Application for Works Approval Amendment

Works Approval Number	W6832/2023/1
Works Approval Holder	Talison Lithium Australia Pty Ltd
ACN	139 401 308
File Number	DER2023/000532
Premises	<p>Talison Greenbushes Lithium Mine – Village Wastewater Treatment Plant</p> <p>1130 Maranup Ford Road</p> <p>GREENBUSHES WA 6254</p> <p>Legal description –</p> <p>Mining tenements L70/232, L70/244, M01/3, M1/06 and M01/7</p> <p>As defined by the Premises map attached to the Revised Works Approval</p>
Date of Report	21 May 2024
Decision	Revised works approval granted

Works Approval: W6832/2023/1

Figure 3: WWTP treated wastewater pipeline

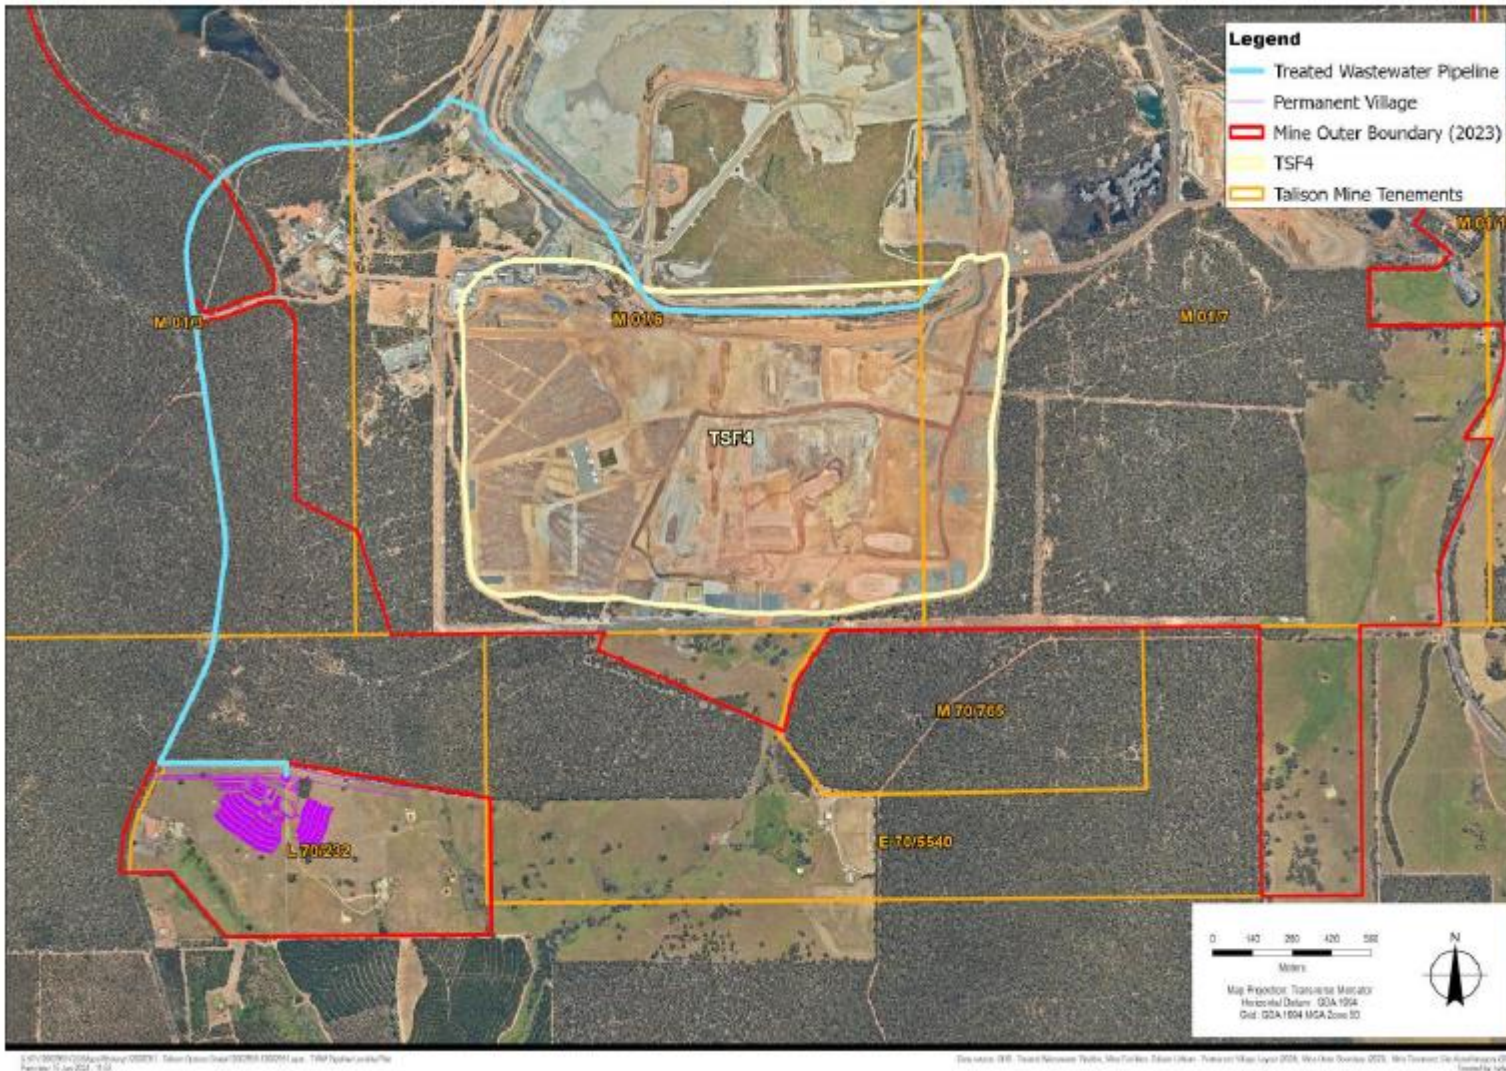
<p>Works Approval Holder was provided with draft amendment on 02 May 2024</p>	<p>The Works Approval Holder provided the following comments on 21 May 2024 and waived the remaining comment period:</p> <p>As per Figure 3 in the draft Works approval the current WWTP has three balance tanks (3 x 50 kL). The expansion will involve the addition of a fourth tank. Table 1, a, ii only lists two balance tanks instead of three. The Works Approval Holder would like to request Table 1,a,ii is amended to align with Figure 3.</p> <p>In the draft amendment report it is noted there is a misspelling of the Shire of Bridgetown-Greenbushes in section 2.2.3.</p>	<p>Table 1,a,ii updated to 3 x balance tanks (50 kL each)</p> <p>Corrected</p>
